**Attachment 1a**  
**Common Question 53**

After further investigation we propose that Question 53 be deleted due to no correct answer.

## Attachment 2

## SRO Question 77

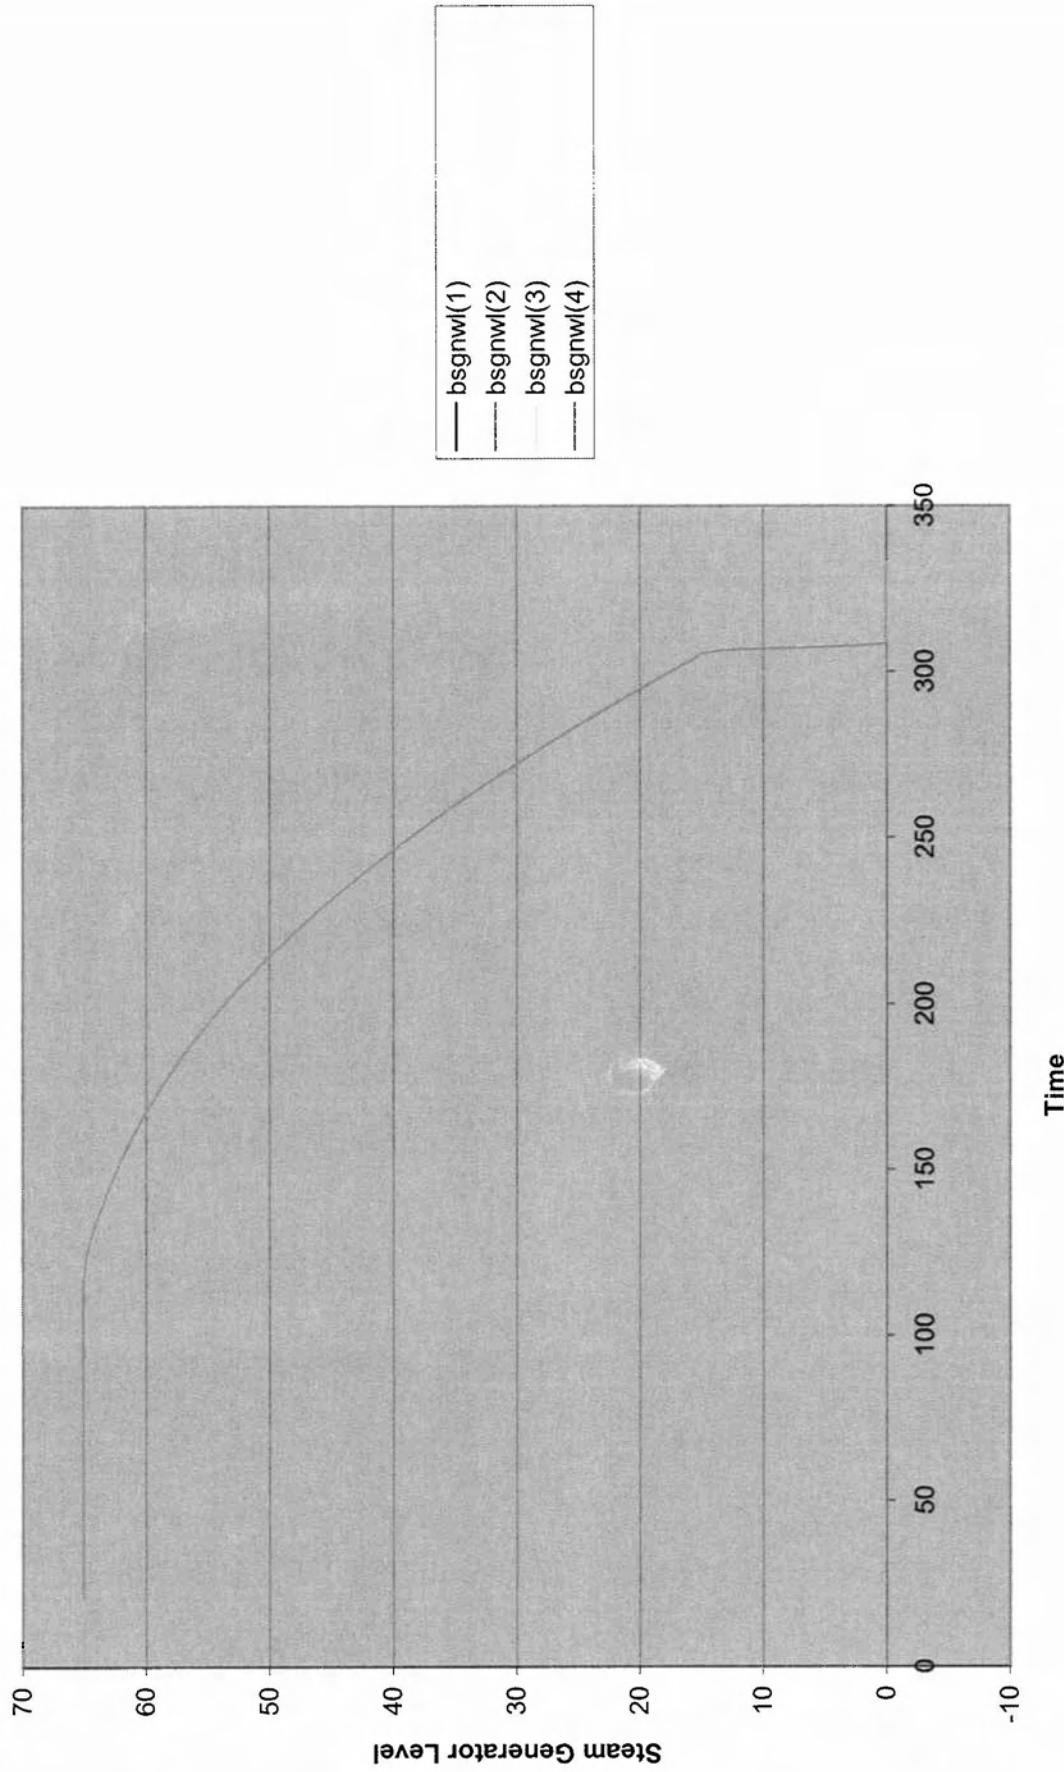
Question 53 was revised to its current state around 2-26-08. “C” distracter was validated on the simulator where a loss of VI did result in a FWP trip, turbine trip, then reactor trip. However we simulated a catastrophic break on VI, where the pressure dropped rapidly.

As a result of our post-exam item analysis, we ran the slower VI leak on the simulator to more closely resemble the conditions described in the question stem. That's when we realized that the FWP will not trip as described on page 1.

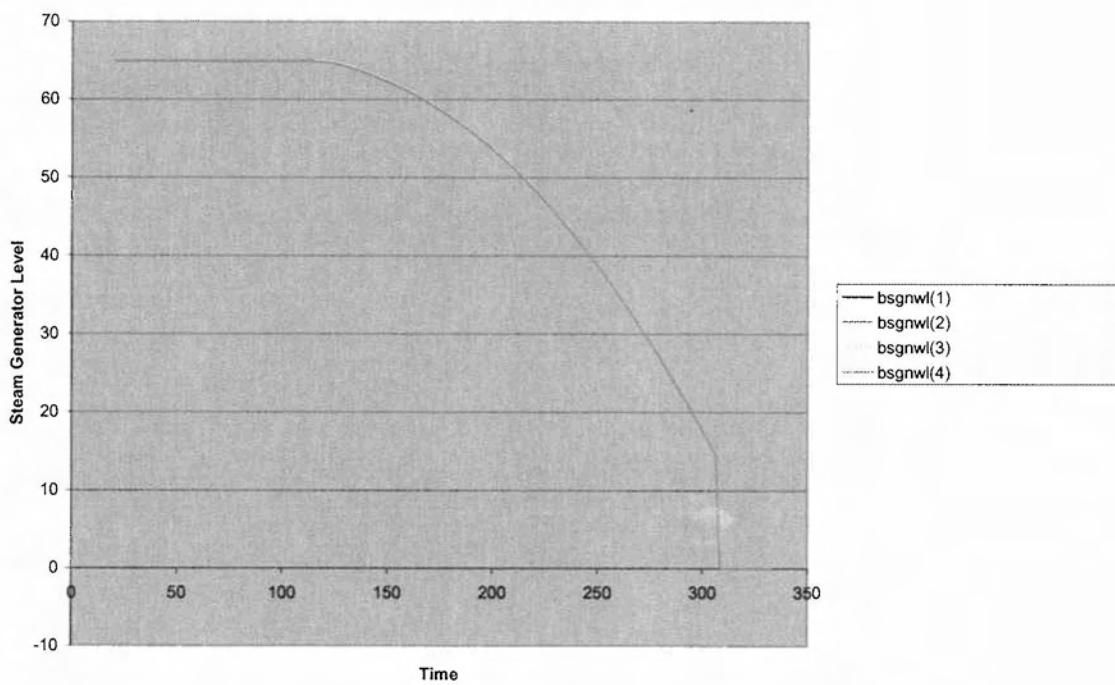
Question 53 was revised to its current state around 2-26-08. “C” distracter was validated on the simulator where a loss of VI did result in a FWP trip, turbine trip, then reactor trip. However we simulated a catastrophic break on VI, where the pressure dropped rapidly.

As a result of our post-exam item analysis, we ran the slower VI leak on the simulator to more closely resemble the conditions described in the question stem. That's when we realized that the FWP will not trip as described on page 1.

**Steam Generator Level**

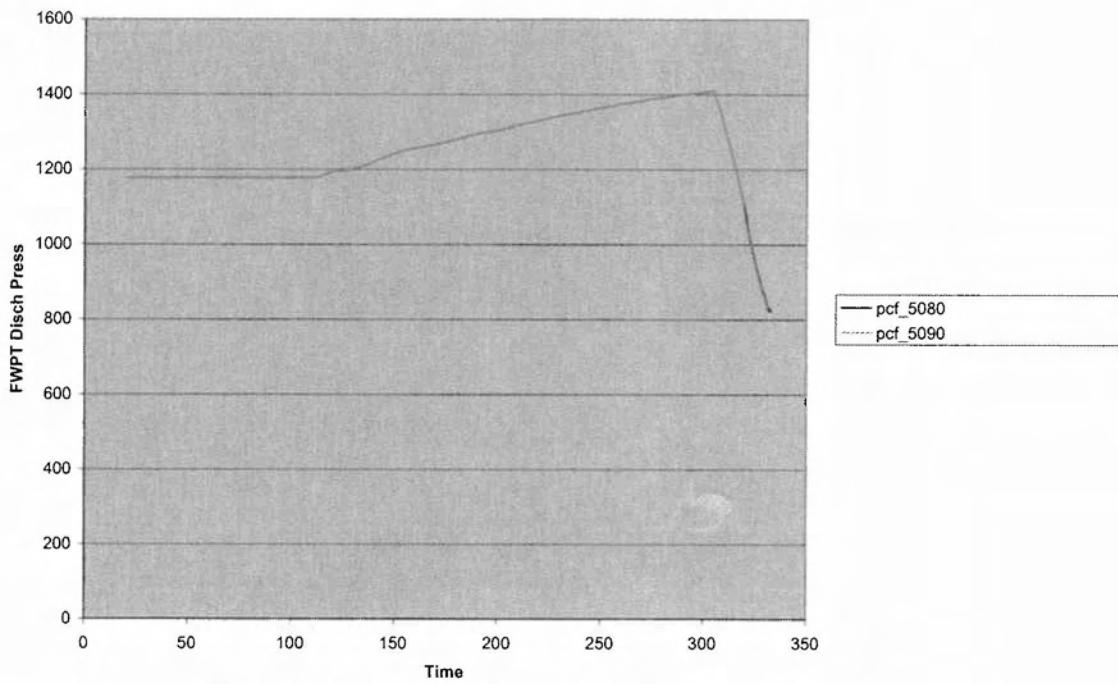
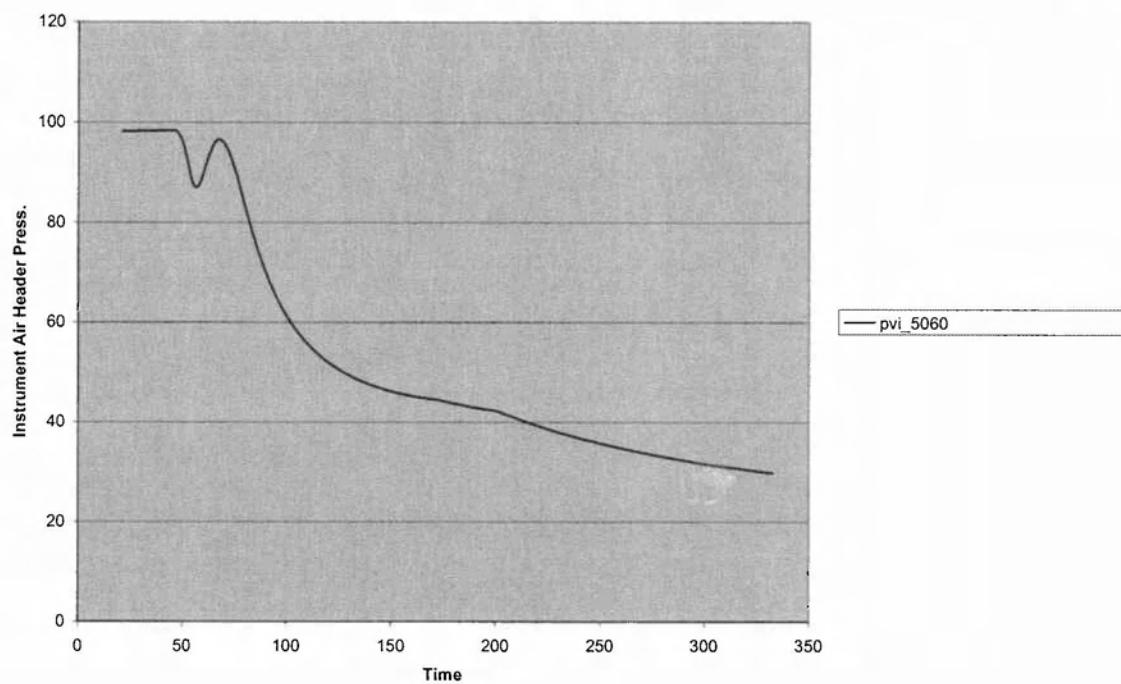
The simulator was set up with a standard 100% MOC snap. A malfunction was inserted consisting of ramped 75% break of the Service Building VI (Instrument Air) header. Over the first 30 sec, VI pressure falls fairly rapidly to a value of approximately 65 PSIG. At this point the FRV demand begins to increase indicating that the actual valve position is closing due to the lower VI header pressure. The result of the FRV's going closed shows that the FW header/Main Steam header D/P begins to increase due to the resulting increase in FWP discharge pressure. This results in a control action by the FWPT Speed control system lower FWPT speed in an attempt to control the D/P at setpoint. These values are shown on the attached graph. At approx. 65 psig the rate of VI pressure decrease slows which would be consistent with the automatic response of the standby VI compressors starting/loading attempting to restore VI pressure. Over the next 3 minutes, VI pressure continues to lower resulting in further closure of the FRV's thereby further reducing feed flow to the S/G's. FWP discharge pressure continues to increase as the FRV's close but the FWPT control system is continuing to decrease the FWPT speed which dampens and slows this effect to the point where the reduction of feed flow to the S/G's results in a low level trip of the Reactor at 17% level approximately 4.5 minutes into the failure with VI pressure indicating about 30PSIG. Just prior to the trip, FWP discharge pressure peaks at approx. 1400 PSIG which is well below the trip setpoint of 1435 PSIG.

Below I have pasted Excel Spreadsheet trends converted from the Simulator Data Recorder depicting the behavior of S/G level, FWP Discharge pressure, and VI Header pressure during the malfunction described above. The X Axis is showing the Time in seconds. I have also attached an Excel file to this communication with the raw data of the selected parameters and additional trends created from this data.
